Technical Service Bulletin

SUBJECT:			No: TSB-18-16-001
TORQUE UPDATES: UNITS OF TIGHTENING TORQUE & NUMERICAL VALUE FOR ENGINE ELECTRICAL - SERVICE MANUAL REVISION			DATE: December 2018
			MODEL: See below
CIRCULATE TO:	<input type="checkbox"/> GENERAL MANAGER	<input checked="" type="checkbox"/> PARTS MANAGER	<input checked="" type="checkbox"/> TECHNICIAN
<input checked="" type="checkbox"/> SERVICE ADVISOR	<input checked="" type="checkbox"/> SERVICE MANAGER	<input checked="" type="checkbox"/> WARRANTY PROCESSOR	<input type="checkbox"/> SALES MANAGER

This TSB updates the Engine Electrical section of the affected Service Manuals to correct the tightening torque of the generator assembly disassembly and assembly removal and installation.

AK703147AC

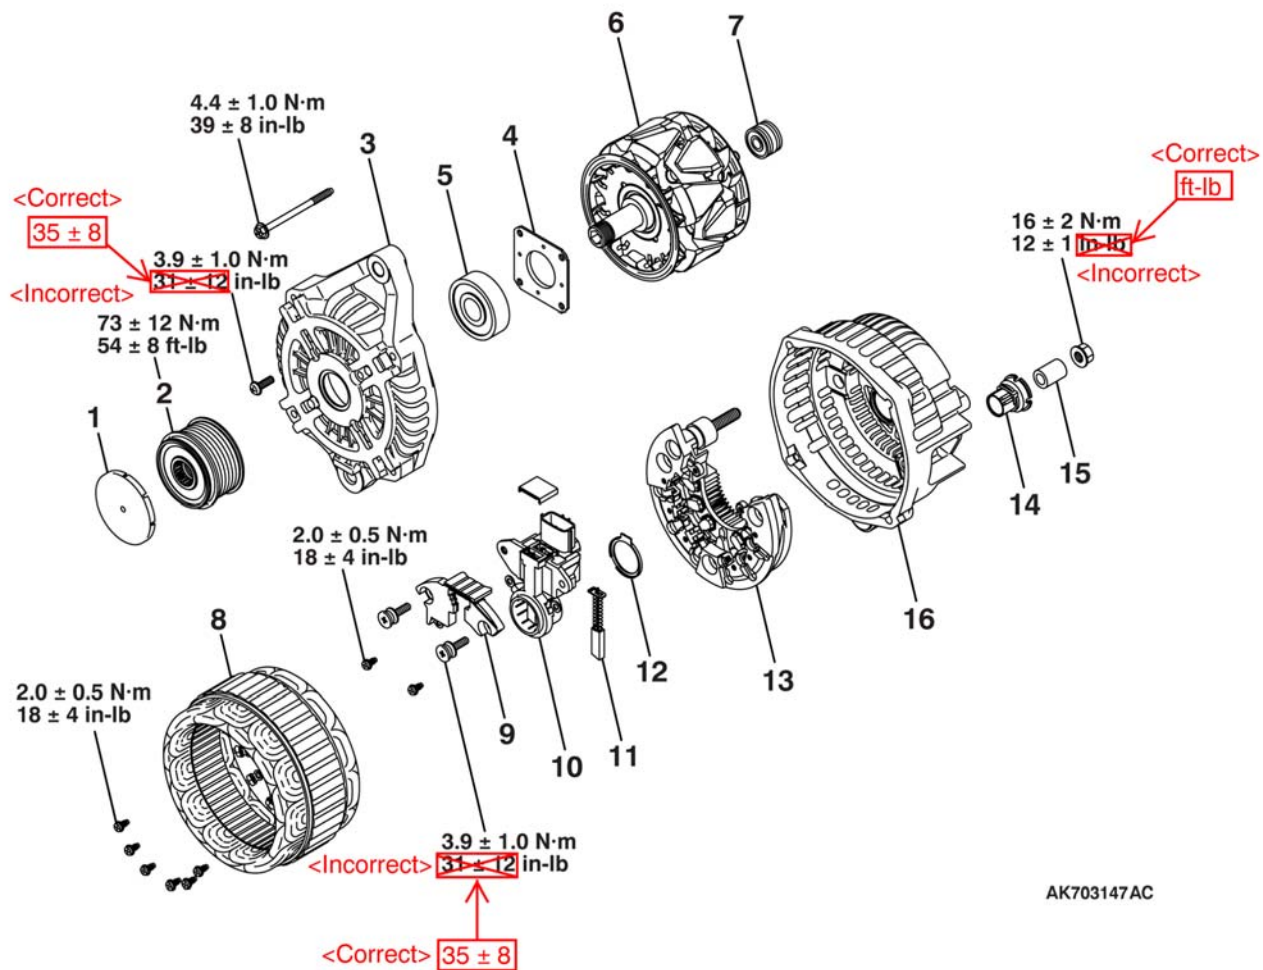
Please make the indicated changes to the 2009 - 2012, 2016 & 2017 Lancer, 2009 - 2014 Lancer Evolution 2016 & 2017 Lancer Sportback Service Manual, Group 16 - Engine Electrical -> Charging System -> Disassembly and Assembly.

<2.0L ENGINE>

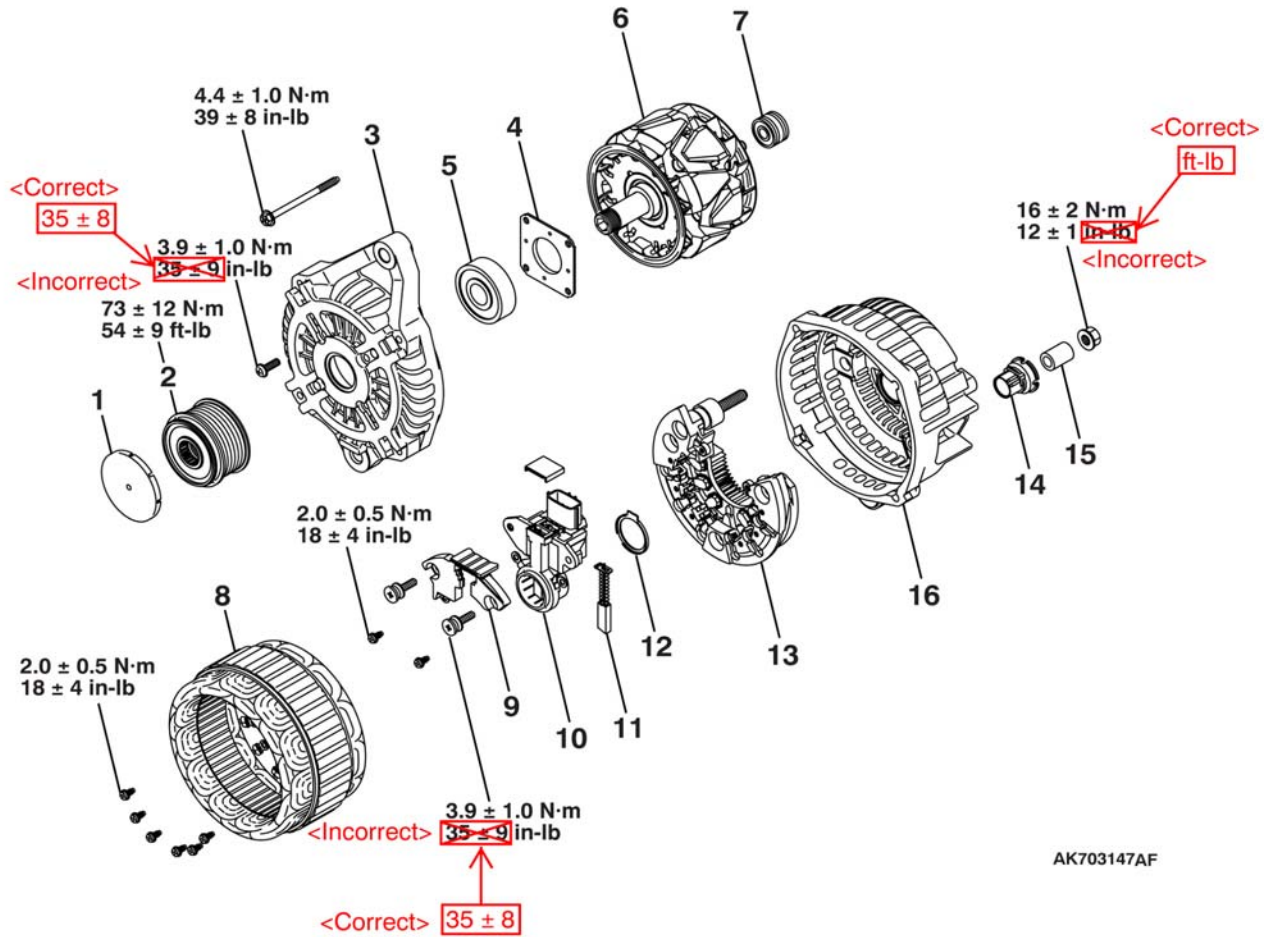
Please make the indicated changes to the 2009 & 2010 Lancer Sportback Service Manual, Group 16 - Engine Electrical -> Charging System -> Disassembly and Assembly.

<2.4L ENGINE>

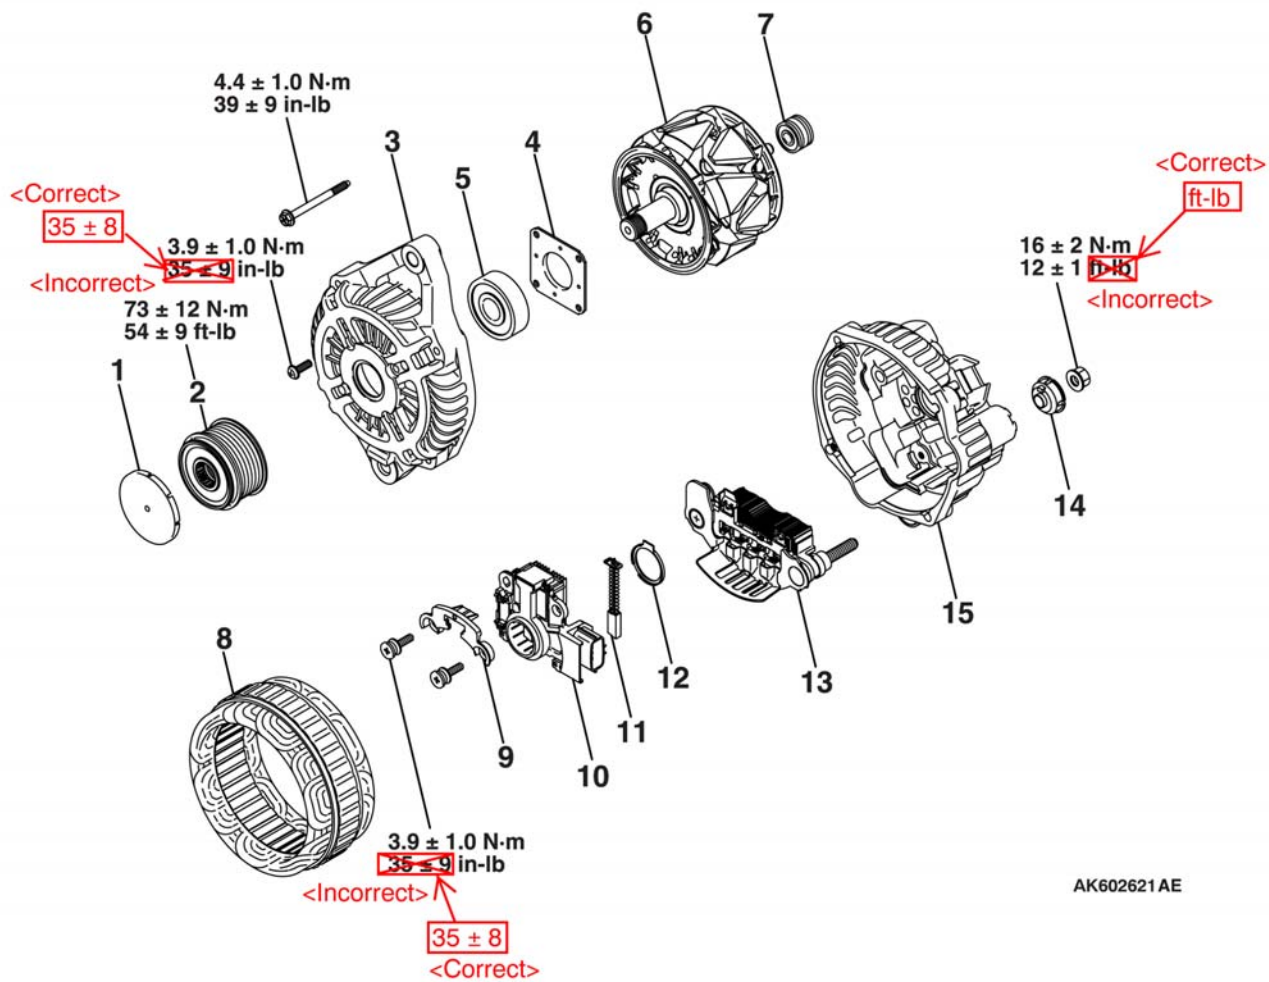
Please make the indicated changes to the 2009 & 2010 Lancer Sportback Service Manual, Group 16 - Engine Electrical -> Charging System -> Disassembly and Assembly.

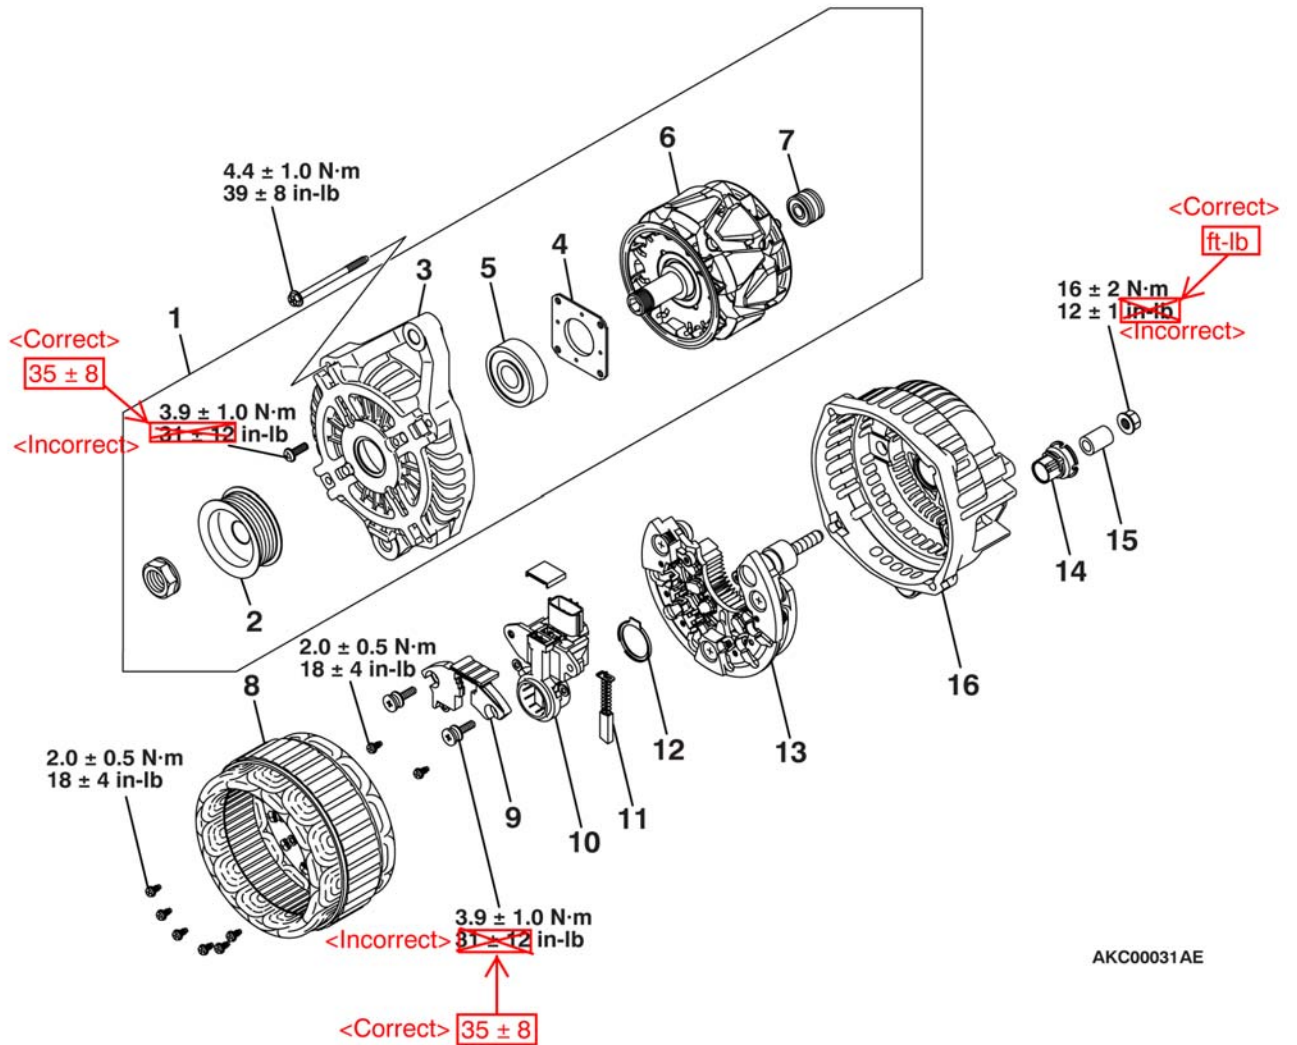
Please make the indicated changes to the 2013 - 2014 Lancer / Lancer Sportback Service Manual, Group 16 - Engine Electrical -> Charging System -> Disassembly and Assembly.

DISASSEMBLY AND ASSEMBLY

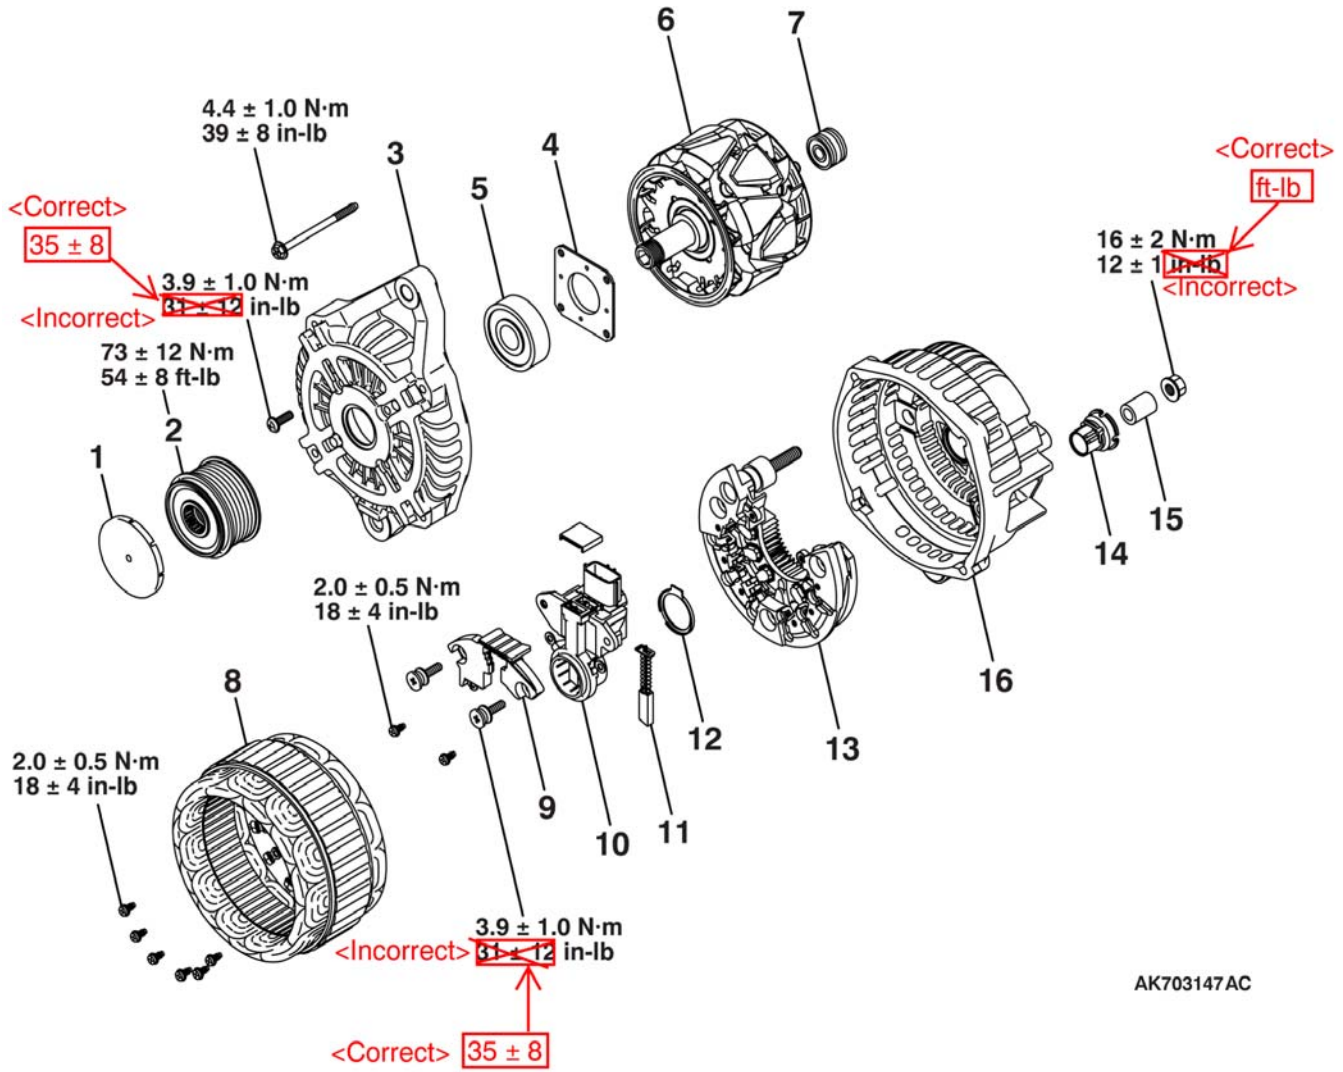
Please make the indicated changes to the 2013 - 2014 Lancer / Lancer Sportback Service Manual, Group 16 - Engine Electrical -> Charging System -> Disassembly and Assembly.
